# Amendment Notice 2

**Licence Number** L8558/2011/1

**Premises** DeGrussa Copper-Gold Project  
Mining Tenement 52/1046  
MEEKATHARRA WA 6642

**Date of Amendment** 9 May 2018

**Figure 1: Location of proposed new thickener and filter**

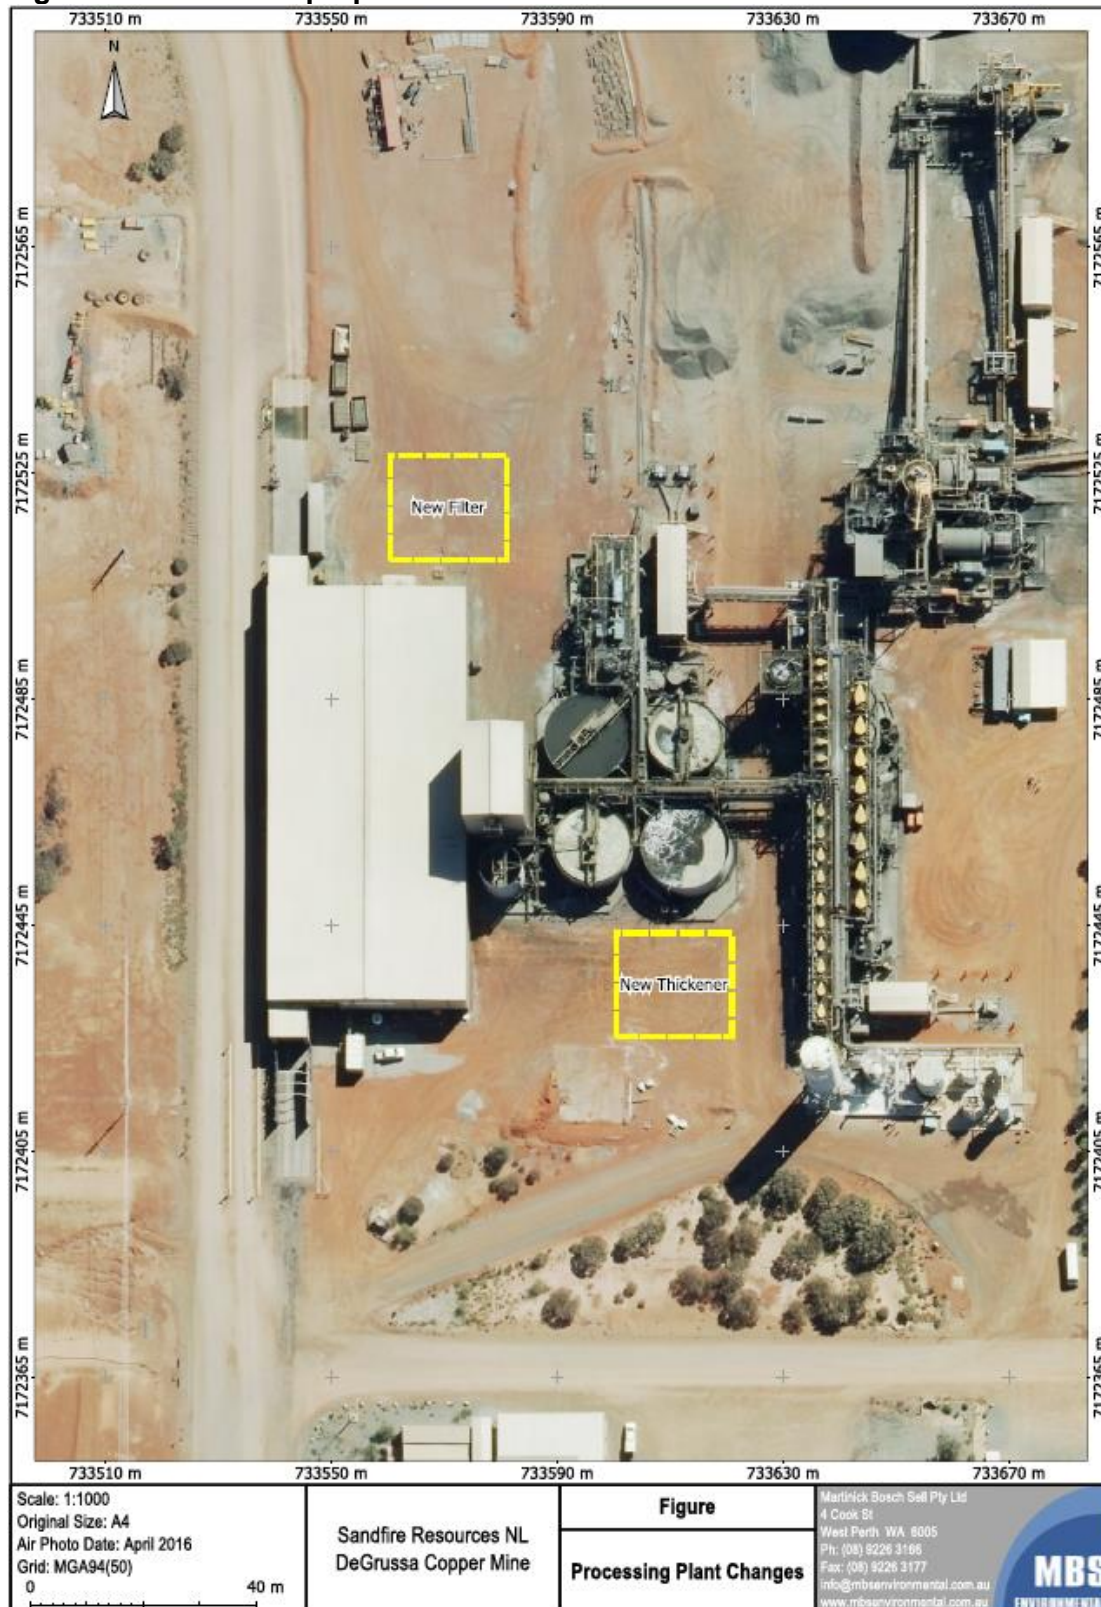
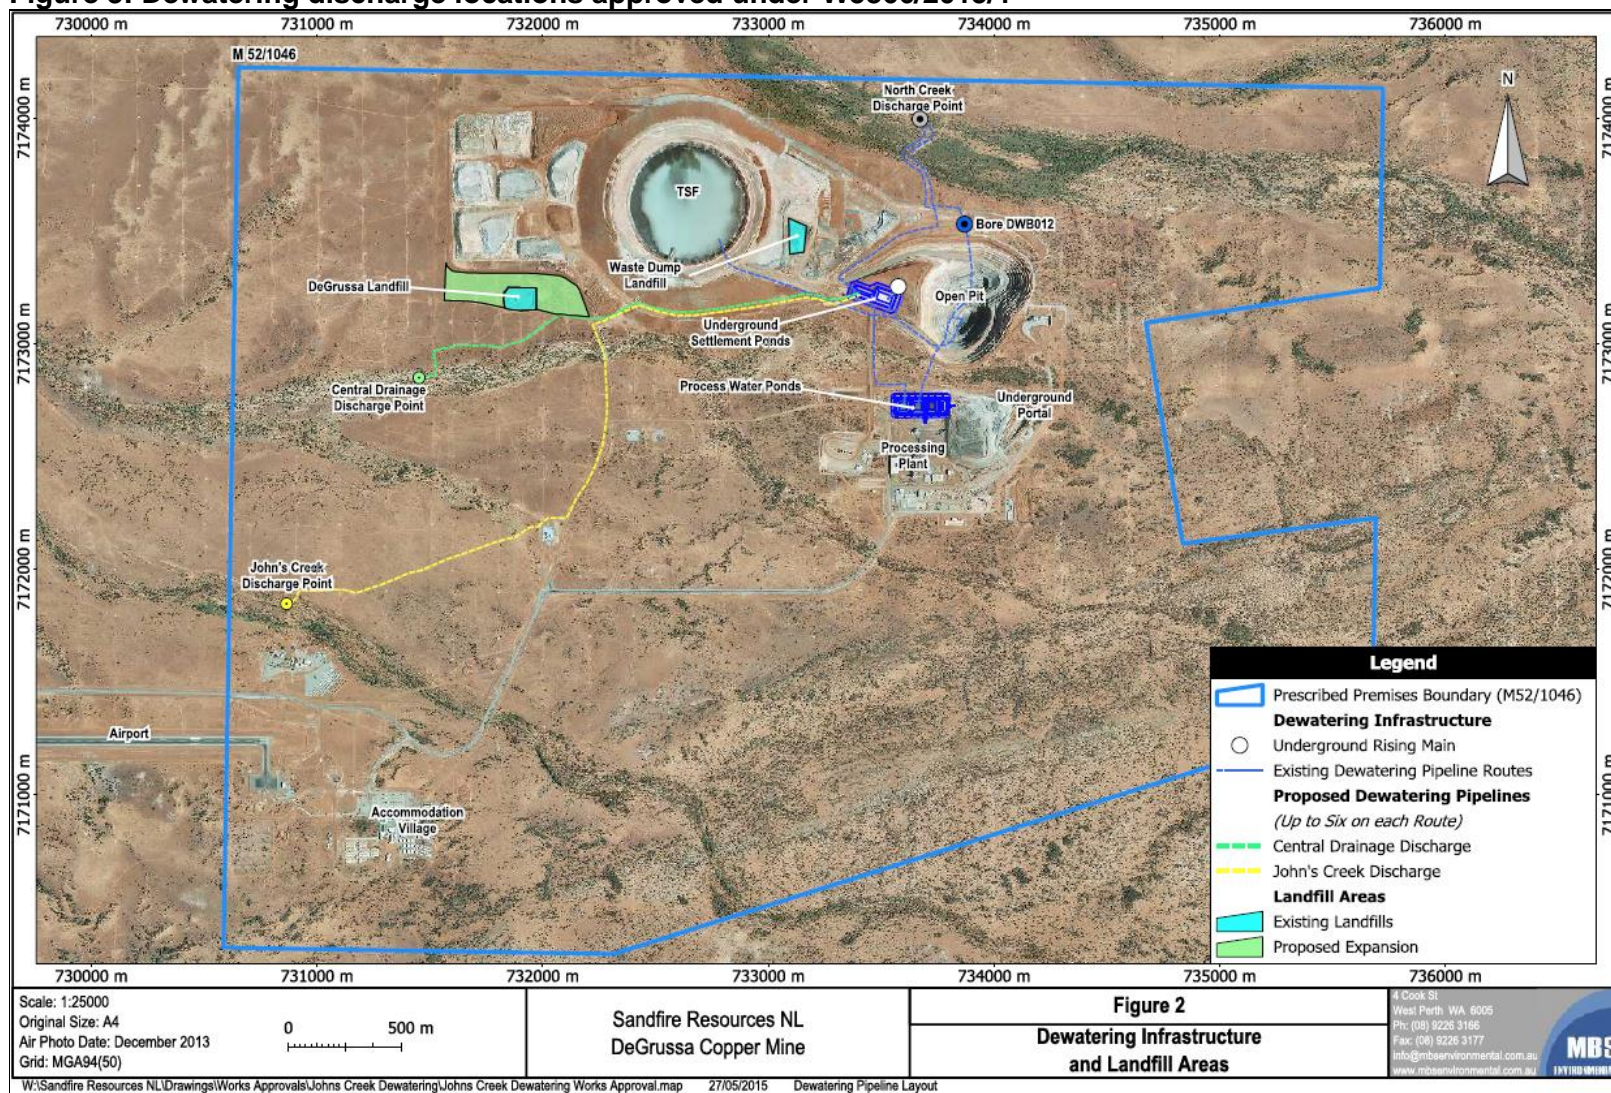
The location of the proposed thickener and filter is shown in Figure 1 below. Figure 2 is a process flow diagram of the thickener and filtration process.

The current 14 m diameter thickener will be replaced by an 18 m diameter thickener in order to increase tonnage concentrate handling ability from 285 kilotonnes (kt) to 400 kt. The thickener is an in-process unit operation taking final concentrate from 20% solids feed to 65% solids, discharging into the existing filter feed tank. The thickener will be located within a concrete bund. Overflow water within the thickener will be returned to the process water tank for re-use in the process plant.

An additional concentrate filter (capable of 26 tonnes per hour) will be installed to complement the existing filter. It will be integrated with the northern end of the existing Concentrate Shed by approximately 18 m and will maintain the current design intent. The new filter will include a fully bunded concrete floor.

**Figure 3: Dewatering discharge locations approved under W5866/2015/1**

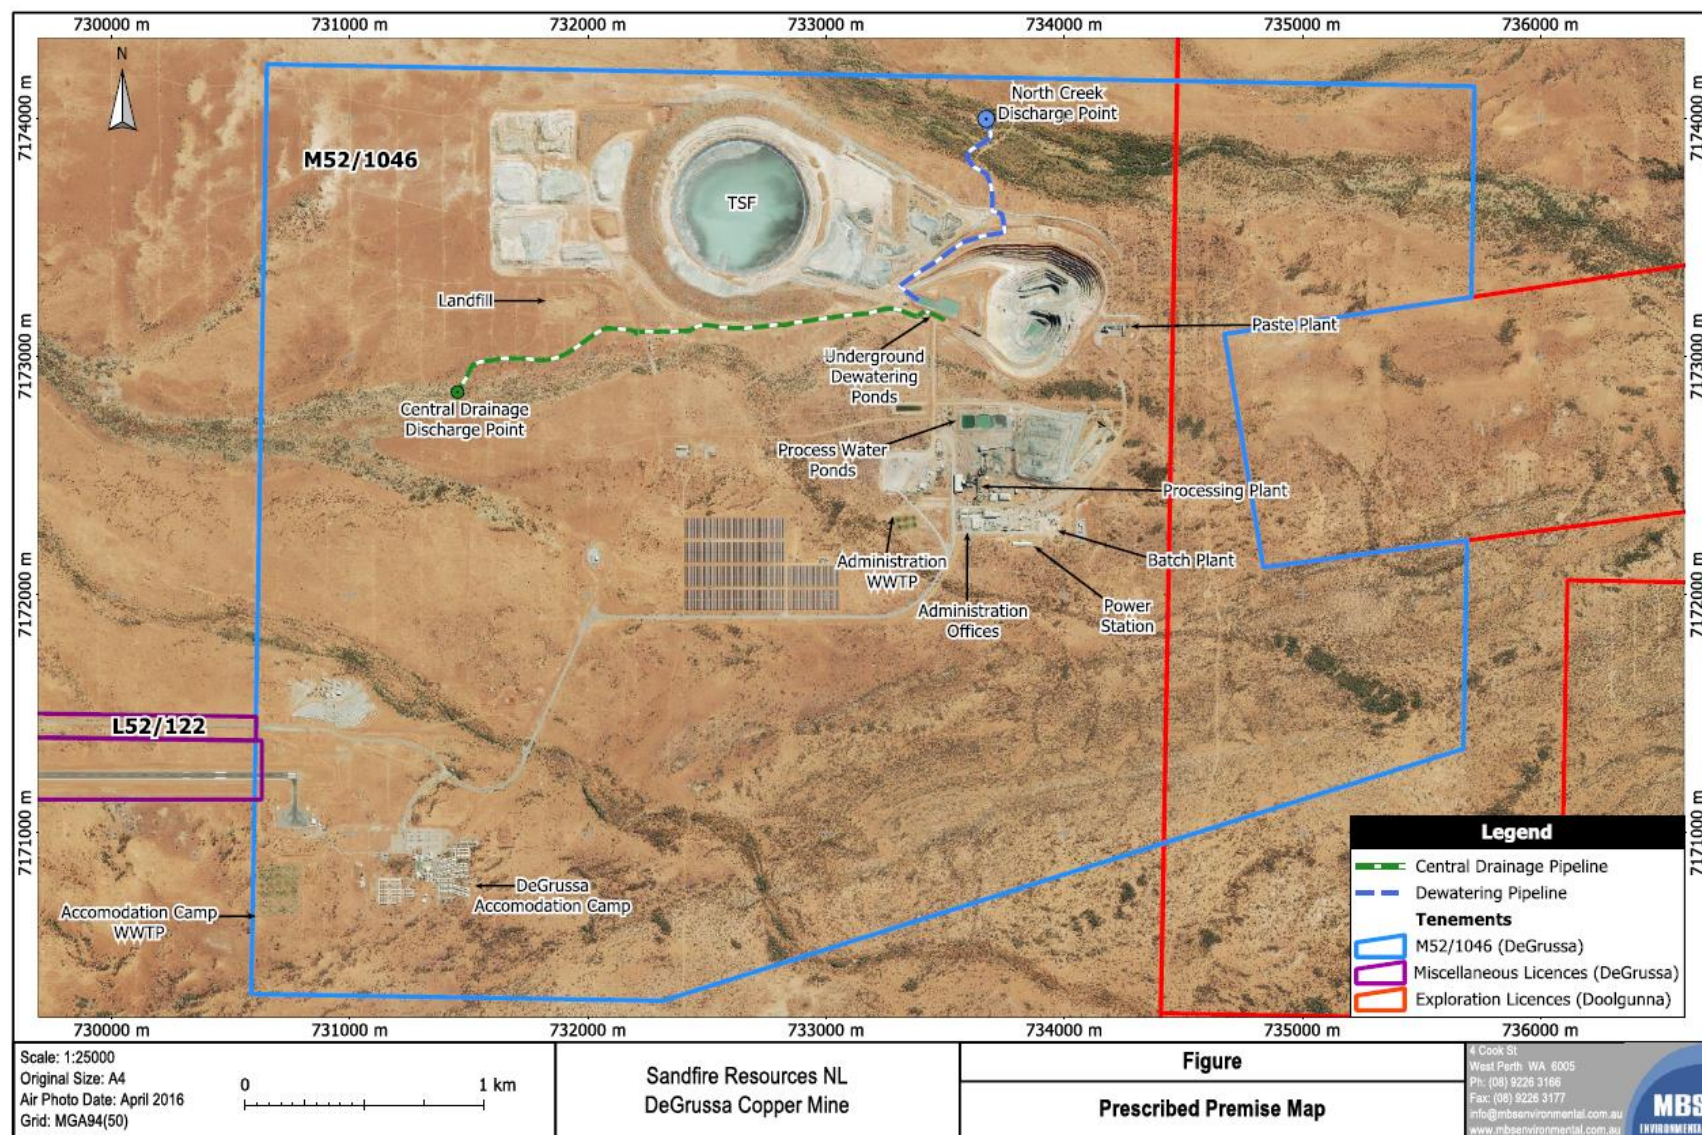
Works Approval W5866/2015/1 was issued on 15 October 2015 for construction of the proposed pipelines and discharge points as shown in Figure 3 below. The following information is from the W5866/2015/1 Decision Document:

Map of emission points **and storage locations**

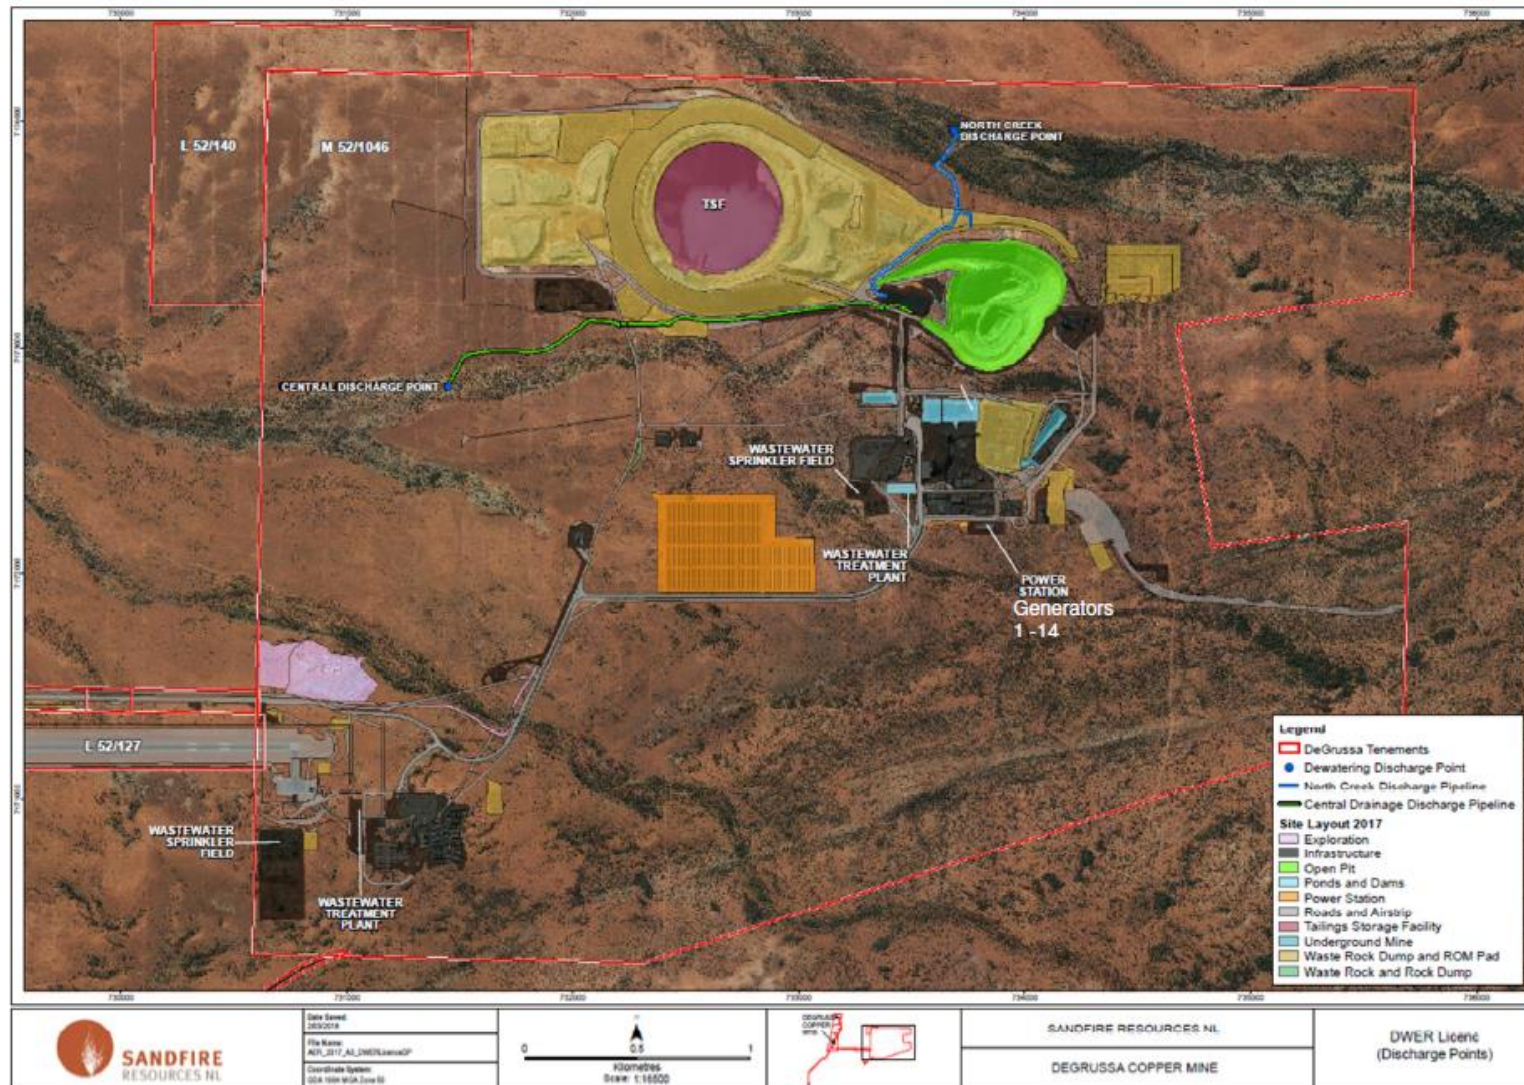
11. Schedule 1: Map of emission points - the map of 'location of emission point in Table 2.3.1' and 'map of monitoring points defined in Table 3.5.1' in the existing Licence is removed and replaced by the 'Map of emission points and storage locations' below as shown by the bold underlined text below.
12. Schedule 1: Map of monitoring locations – 'locations of monitoring points defined in Table 3.5.1' in the existing licence is removed and replaced by the map below as shown in bold underlined text below.
13. Schedule 1: Map of storage locations – 'location of the storage area (TSF) defined in Table 1.3.3' in the existing licence is removed and replaced by the Map of emission points and storage locations as shown in bold underlined text below.
14. Schedule 2: Reporting and Notification forms Annual Audit Compliance Report (AACR) Proforma is removed.

**The locations of the emission points defined in Tables 2.2.1 and 2.3.1 and the storage area (TSF) defined in Table 1.3.3 are shown in the map below.**

Map of monitoring locations

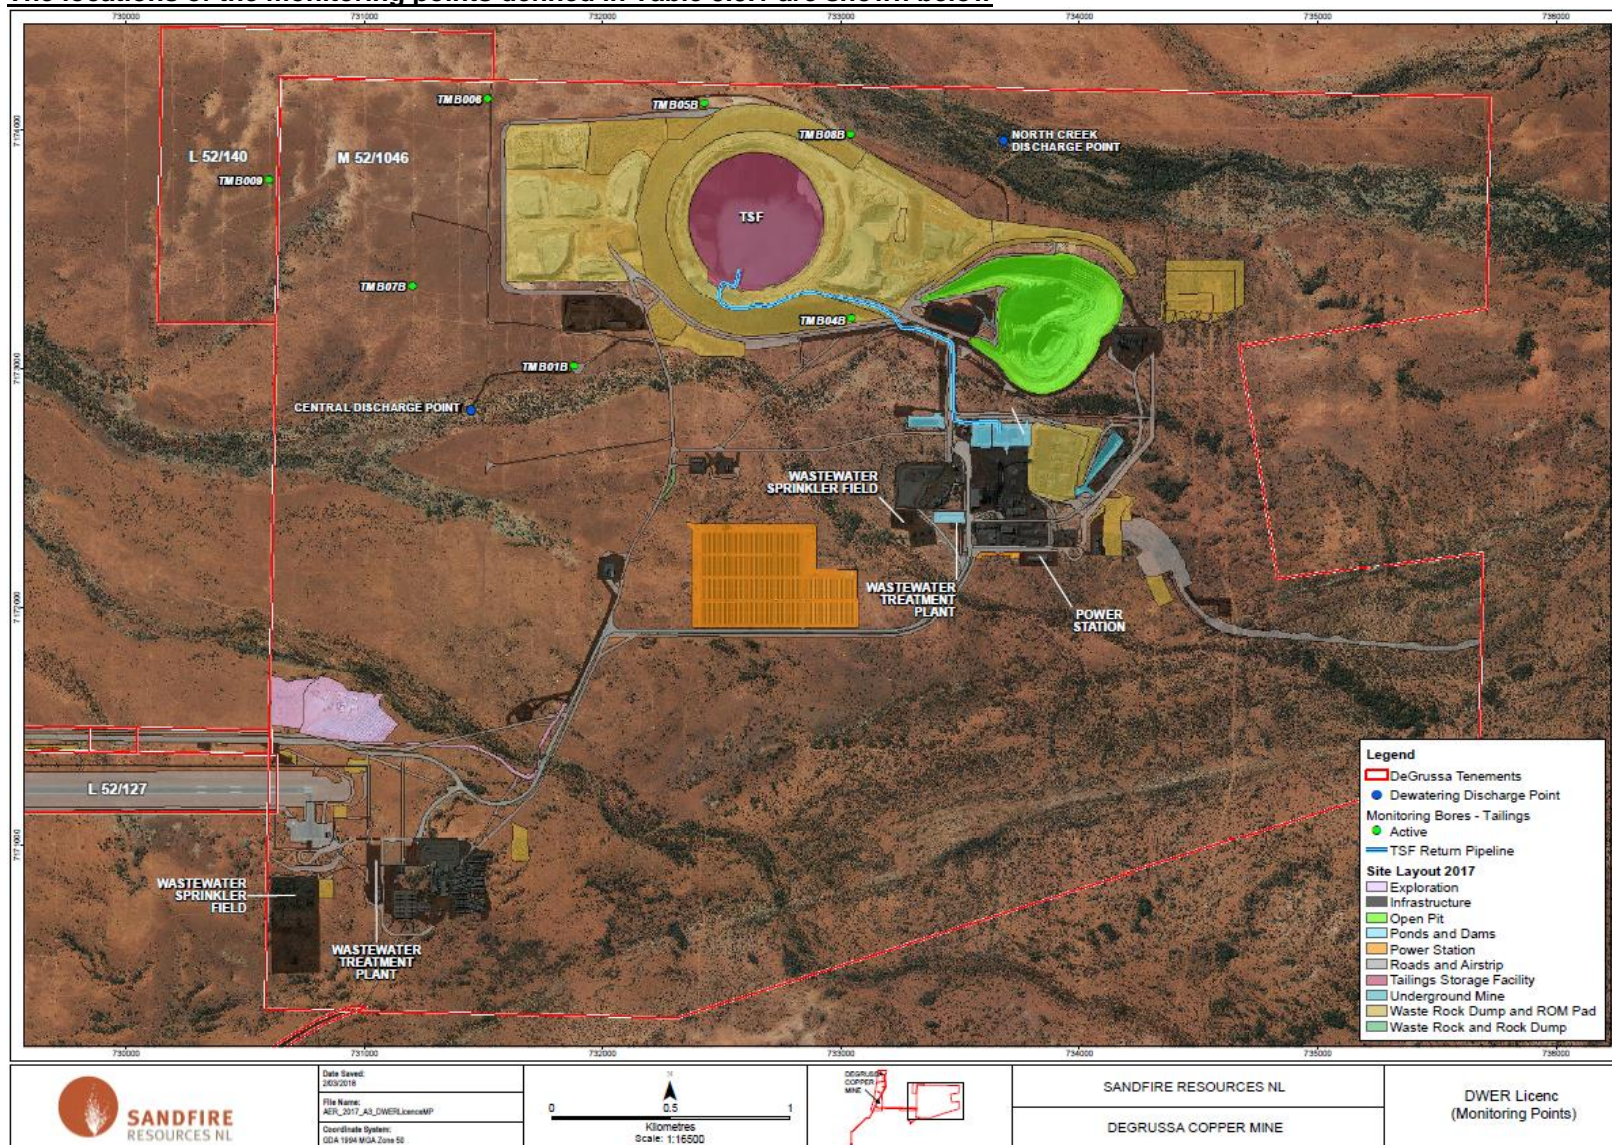
TSF monitoring bores TMB01, TMB04, TMB05, TMB07, and TMB08 have run dry due to dewatering activities. New monitoring bores have been drilled at a depth of 100 metres (m) in the vicinity of the existing bores to enabling sampling and analysis of water quality. The new bores have been named TMB01B, TMB04B, TMB05B, TMB07B, and TMB08B. TMB006 remains the same.

The locations of the monitoring points defined in Table 3.5.1 are shown below

Table 3.5.1: Monitoring of ambient groundwater quality				
Monitoring point reference	Parameter	Units	Averaging period	Frequency
<del>TMB01</del> <b><u>TMB01B</u></b> , <del>TMB04</del> <b><u>TMB04B</u></b> , <del>TMB5</del> <b><u>TMB05B</u></b> , <del>TMB6</del> , <b><u>TMB006</u></b> , <del>TMB7</del> <b><u>TMB07B</u></b> , and- <b><u>and</u></b> <del>TMB08</del> <b><u>TMB08B</u></b>	arsenic	mg/L	Spot sample	Quarterly
	cadmium			
	chromium			
	copper			
	lead			
	<u>manganese</u>			
	<u>molybdenum</u>			
	pH <sup>1</sup>	-		
	<u>nickel</u>	mg/L		
	selenium			
	standing water level	mbgl		
	sulphate	mg/L		
	total dissolved solids			
	total acidity			
	<u>vanadium</u>			
	<u>uranium</u>			
	zinc
